Report of Dam Safety Assessment of Coal Combustion  
Surface Impoundments  
Westar Energy  
Tecumseh Energy Center, Tecumseh, KS

AMEC Project No. 3-2106-0183.0001

May 2011

9

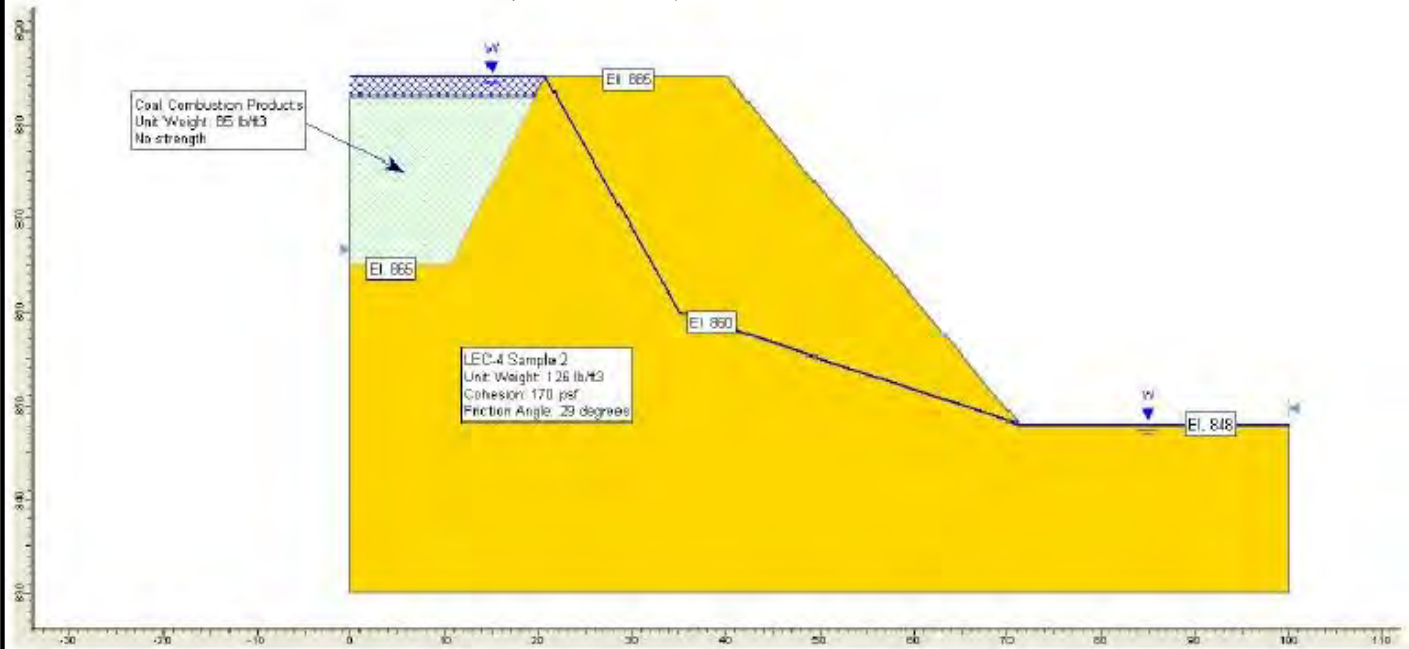
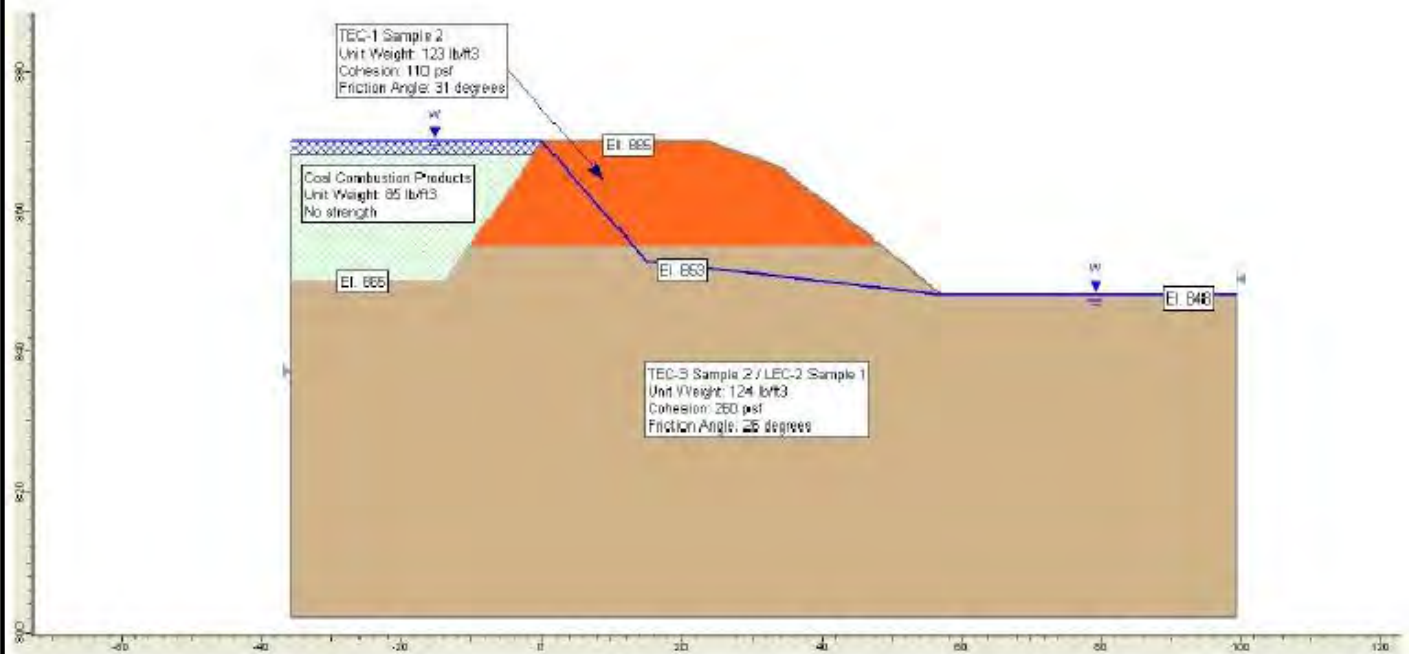
Two cross sections, Section 1 and Section 2, were located to represent critical slope conditions with respect to stability. Figure 9 illustrates the cross section locations as chosen by Golder for the 2009 stability analyses as well as site topographic information provided by Westar Energy. Golder "conservatively assumed that the staging areas were filled with CCP's to an elevation two feet below the berm crests and that ponded water reached the same elevation as the berm crests." Further, based on their visual observation of the drained and cleaned north pool of the Area 1 pond, Golder assumed the depth of the CCP storage facility to be 20 feet. A 0.5 to 1.0 (H:V) slope ratio was chosen for the upstream embankment slopes, apparently based on the same visual assessment by Golder.

The report notes that for "purposes of the stability analyses, Golder represented distinct soil layers and assigned engineering parameters based on proximity to sampling locations, field soil classification and laboratory test data." Figure 10 illustrates the 2009 stability analyses Section 1 (Area 1 Pond) and Section 2 (Area 2 Pond), including assigned engineering parameters. Unit weights were assigned to each soil layer based on "density testing of undisturbed soil samples collected at TEC." The boring identification appears to have been inadvertently left out of the document. Further, the report noted with regard to parameters,

Following the initial stability calculations, Golder performed additional analysis and determined that acceptable factors of safety would be obtained for Section 1 if the existing slope was decreased (flattened), specifically to 1.7:1 (H:V). Calculated factor of safety values for the flattened slope section were determined to be 1.5 and 1.3 for static and seismic conditions, respectively. Figure 11 illustrates the boundaries of the over steep slope area of the Area 1 Pond’s north embankment that would require repair.

12

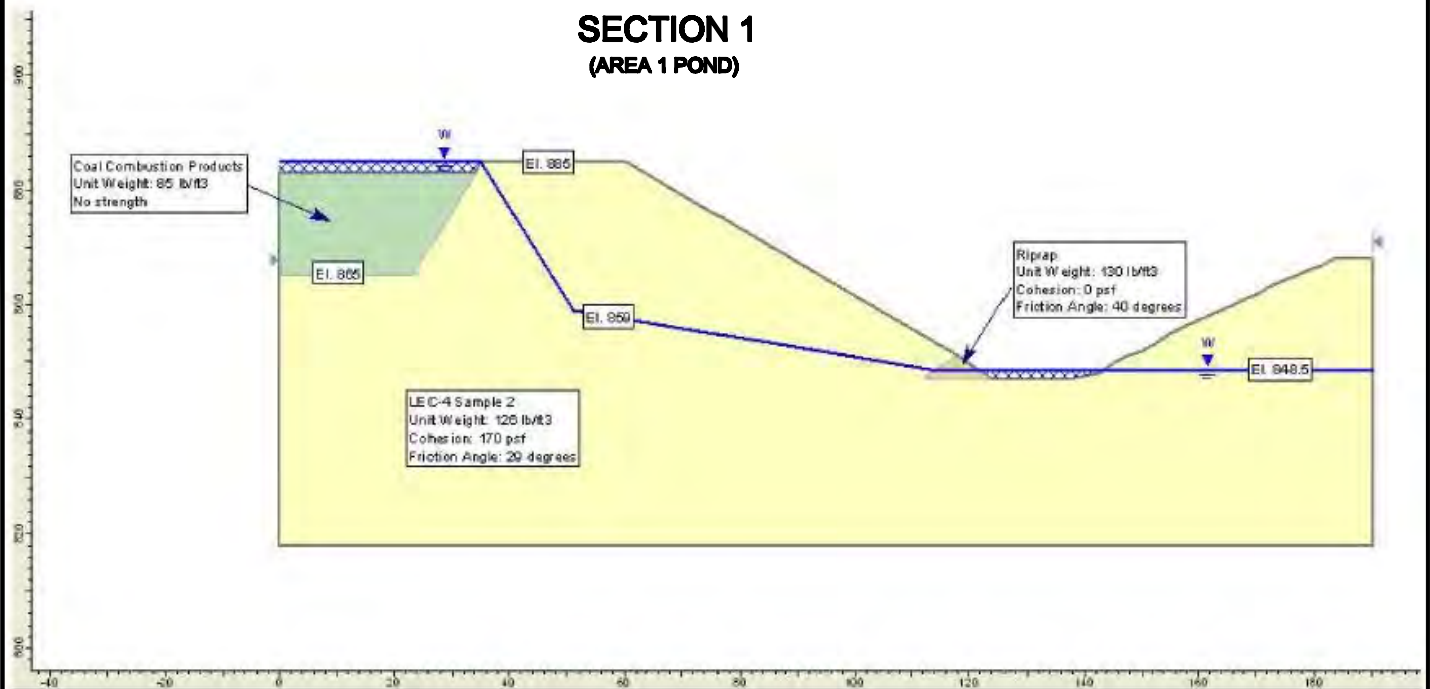
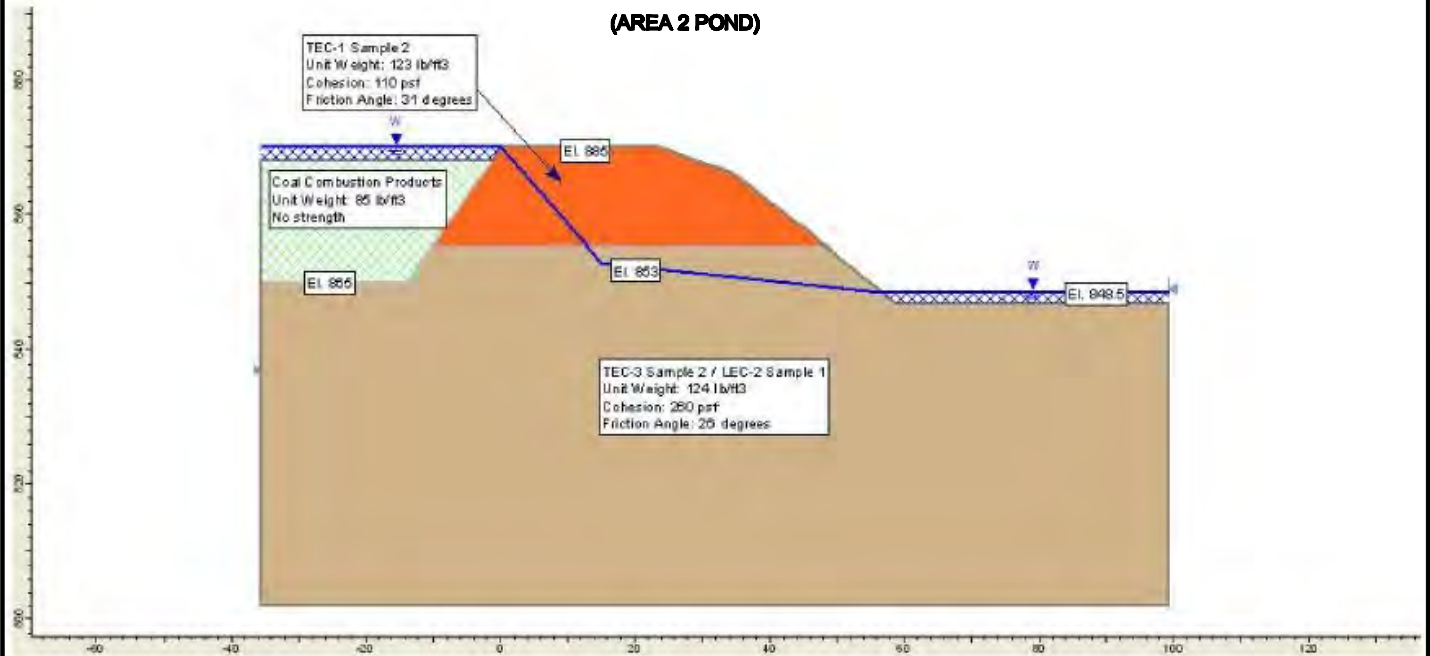
Although several borings had been advanced for the 2009 evaluation of berm stability, two additional borings, P-1 and P-2, were advanced in the northern crest of the Area 1 Pond for the 2010 study, as shown on Figure 12. Piezometers were installed in these borings at locations designed by Golder and Westar, “to better define piezometric levels” in the area. Figure 12 illustrates the piezometer locations. Both piezometers were removed upon completion of the slope regrading project.

The same stability cross section locations were used for the 2010 evaluation; however, the downstream slope of Section 1 was flattened to 1.7: (H:V) as indicated by the additional analysis that followed the 2009 evaluation. Figure 12 illustrates the uniformly regraded north embankment slope of the Area 1 Pond. Figure 13 illustrates the 2010 stability analyses Section 1 (Area 1 Pond) and Section 2 (Area 2 Pond), including assigned engineering parameters. The engineering parameters for the 2010 study included an entry for riprap material, with parameter values as shown on Figure 13, due to the fact that the proposed regrade included riprap
